Product Discontinuation Notices

Safety Door Switches

No. 2011312E

Discontinuation Notice of part of D4NS series

Dimensions

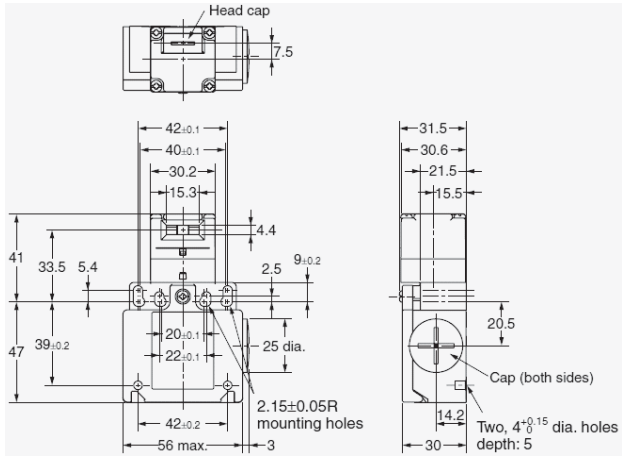
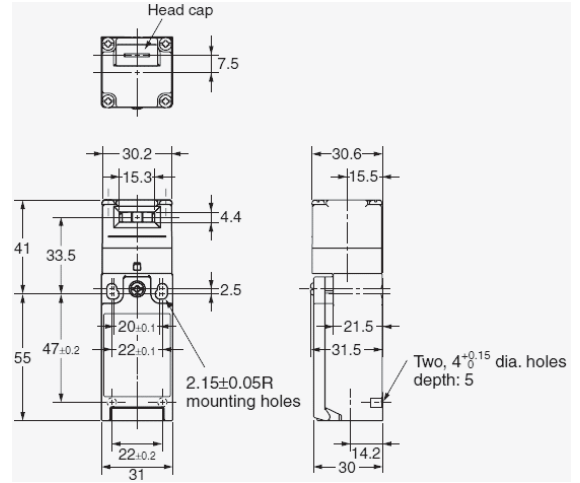
- Appearance and dimensions are different
- Number of conduit and/or conduit size are different

Model D4NS-5□□ / D4NS-7□□

Model D4NS-9□D

Head material: Metal

Model D4NS-4□□

Model D4NS-9□F

Head material: Plastic
